CONTRACT NO. 1797

OHIO RIVER TUNNEL

ADDENDUM No. 5

All bidders bidding **Contract No. 1797** shall read and take note of this **Addendum No. 5**. The Contract Documents for **Contract No. 1797 – Ohio River Tunnel** are hereby revised and/or clarified as stated below.

Contract: 1797

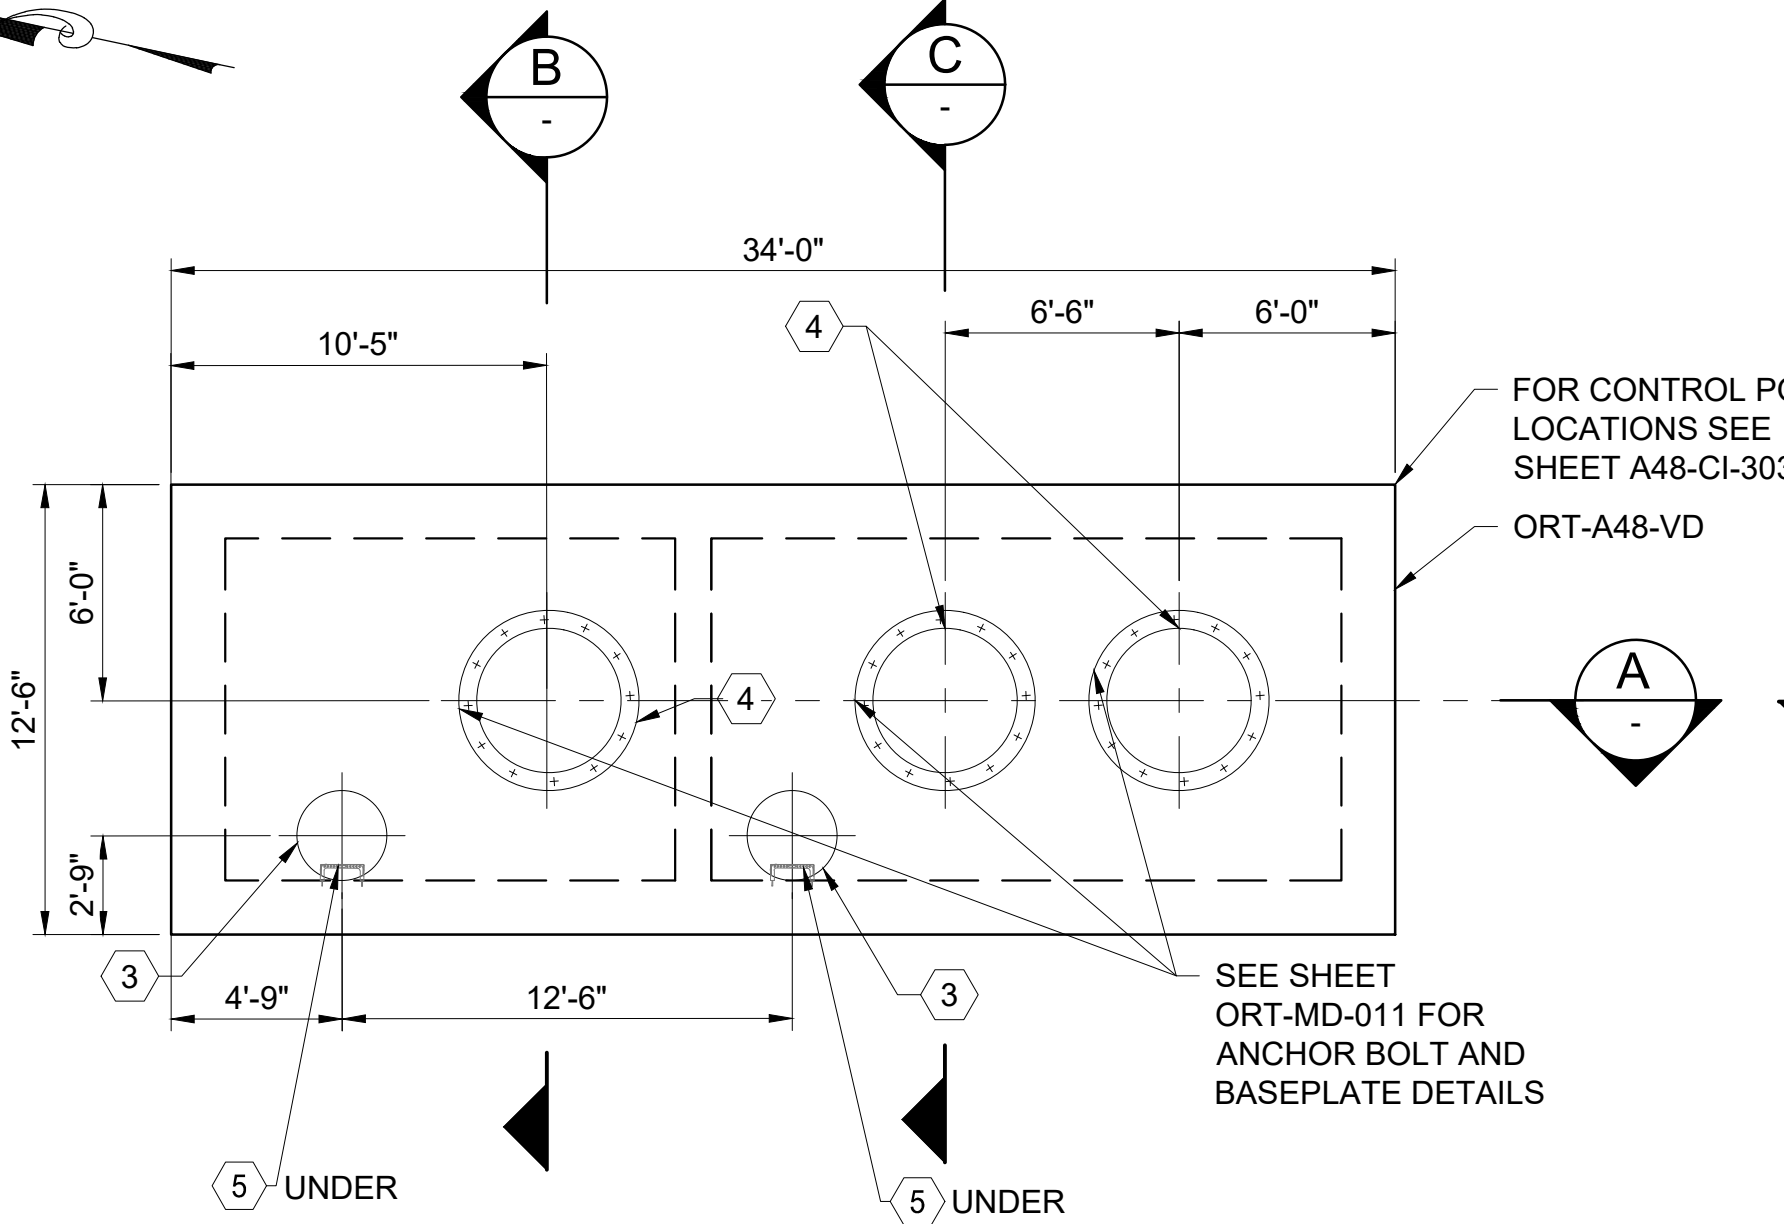
- A2 **This is a dedicated full-time position.**
- Q3 *Ventilation Diffuser SOE - For all sites that contain ventilation diffusers, a support of excavation design is to be designed by the contractor, and submitted to the owner for review and approved. The contract drawings reference in the support of excavation notes under note C, "Any excavation for the ventilation vaults deeper than 4 feet shall be supported by a temporary excavation support system without internal bracing or any elements of the SOE system intruding into the excavation footprint."*

- Please remove these internal bracing restrictions to allow the Contractor and their Engineer to determine the best solution for shoring these excavations.*

- A3 **Drawings O27-ST-142, O27-ST-143, O41-ST-226, A48-ST-315, A58-ST-438, A58-ST-440 O14-ST-628, O07-ST-713, O06A-ST-814, and O06A-ST-815 are revised and attached to this Addendum. See CHANGES TO CONTRACT DOCUMENTS section below and Attachment A of this Addendum.**

- c) DELETE O41-ST-226 (Sheet 341 of 770) and ADD Revised O41-ST-226 (Sheet 341 of 770), which is Attachment A to this Addendum.
- d) DELETE A48-ST-315 (Sheet 376 of 770) and ADD Revised A48-ST-315 (Sheet 376 of 770), which is Attachment A to this Addendum.
